Access Compliance Report

Public Rights-of-Way

Intersection ID: 22902	Main Street: CARMEL_RD	Cross Street: MOORLAND_DR	Location: S
ADA ID: B98F67322112	Ramp Type: PerpDiag	Initial Pass/Fail: Fail	Overall Compliance: No
Severity Score: 13.75			
Codes/Mitigation Info/Possible Solution		Field Measurements/Component Compliance

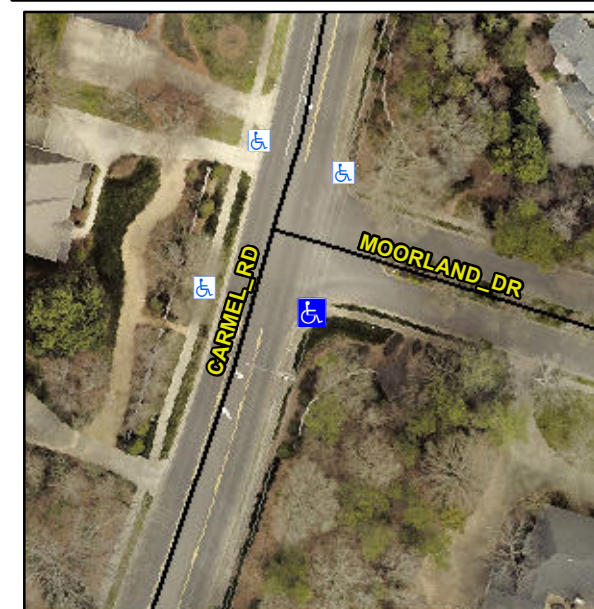
Not Found, R304.2.2, R304.5.3

Compliance	Description	Data	Compliance	Description	Data
N/A	Ramp Length (in)	64.0	No	Ramp Slope (%)	8.8
Yes	Ramp Width (in)	48.0	No	Ramp XSlope (%)	2.3
N/A	Flare Type LT	N/A	N/A	Flare Type RT	N/A
N/A	Flare Slope LT (%)	N/A	N/A	Flare Slope RT (%)	N/A
N/A	Flare Traversable LT?	N/A	N/A	Flare Traversable RT?	N/A
N/A	Landing Length (in)	N/A	N/A	DWS Provided?	N/A
N/A	Landing Width (in)	N/A	N/A	DWS Contrast?	N/A
N/A	Landing Slope (%)	N/A	N/A	DWS Length (in)	N/A
N/A	Landing X Slope (%)	N/A	N/A	DWS Full Width?	N/A
N/A	Landing Curb? (Y/N)	N/A	N/A	DWS Offset (in)	N/A
N/A	Shared Landing?	N/A			
N/A	Gutter Ponding?	Yes	N/A	Gutter Slope (%)	N/A
N/A	Gutter Lip Ht (in)	N/A	N/A	Gutter X Slope (%)	N/A
N/A	Painted X Walk1?	No	N/A	Painted X Walk2?	No
	X Walk 1 Direction	To NW		X Walk 2 Direction	To NE
N/A	X Walk 1 Width (in)	N/A	N/A	X Walk 2 Width (in)	N/A
	X Walk 1 Slope (%)	3.8		X Walk 2 Slope (%)	0.8
	X Walk 1 X Slope (%)	1.8		X Walk 2 X Slope (%)	1.7

Remove & Replace Curb Ramp With Two New Directional Ramps or Equivalent.
